NOTICE OF LOCAL PLANNING PANEL MEETING PUBLIC AGENDA

A Local Planning Panel meeting will be held via audio-visual means on Thursday, 21 July 2022 at 3:30pm.

ITEM NUMBER 5.1

30 Stanley Road, EPPING (Lot 1 DP 25650, Lot 2 DP 25650)

Figure 1: Section (Source: L Form Architects)

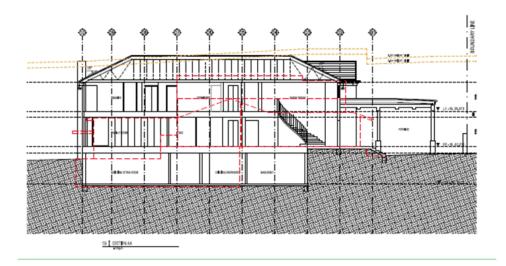
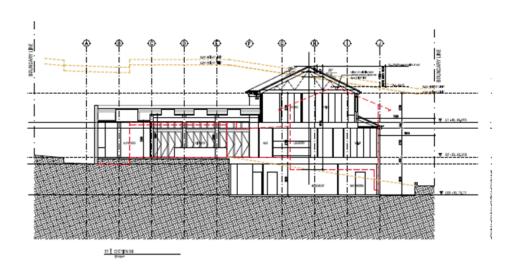
<u>Comment:</u> The area of the dwelling which proposes a variation to the height standard is not currently 3 storeys. The existing dwelling contains split levels which follow the slope of the site. The substantial alterations and additions involve a levelled ground floor and first floor which are not stepped with the slope of site. The proposed development also includes additional floor to ceiling height to the basement, ground floor, and first floor. The applicant states their desire to continue the existing roof form of the dwelling in the addition, however, the area of the dwelling which exceeds the height does not currently demonstrate a pitched roof form and is more alike to a flat or slanted roof form. The proposed roof form is not suitable for the additions as the resultant height exceeds the maximum height identified for the site. As the additions to the rear of the dwelling which exceeds the height standard will not be easily

<u>Comment:</u> The submitted Streetscape Diagram demonstrates that the proposed alterations and additions would result in the front of the dwelling continuing to present as a two storey dwelling from street view of the site. However, the alterations and additions to the dwelling at the rear of the development would be visible from an oblique street view of the site, and from the Council reserve at the rear, and present as unreasonable bulk as result of the proposed roof form.

<u>Comment:</u> The area of the dwelling which proposes a departure to the height control is at the rear of the dwelling and would not be easily visible from street view of the site. The provision of a reduced pitch roof or otherwise flat roof at the rear first storey of the dwelling would result

in the proposal achieving a maximum height which would achieve compliance with the standard. The roof form is deemed to be unnecessarily bulky for the subject development. The preference for a pitched roof consistent with other roofs in the street is under a DCP control. In this instance, compliance with an Environmental Planning Instrument (LEP) is required over a DCP control.

<u>Comment:</u> The constraints the site experiences in regard to slope are not considered to be unreasonable or unnecessary to achieve compliance with, as stepped floor and ceiling levels and a changed roof form to the rear of the dwelling, or otherwise more appropriately siting the additions would result in the dwelling achieving a height permissible under the standard. The development potential would not be limited by achieving a height permissible under the standard, as no issue is raised in regard to the total floor area result from the proposed alterations and additional to the dwelling. The proposed development is not considered to result in the need for additional infrastructure in the locality.
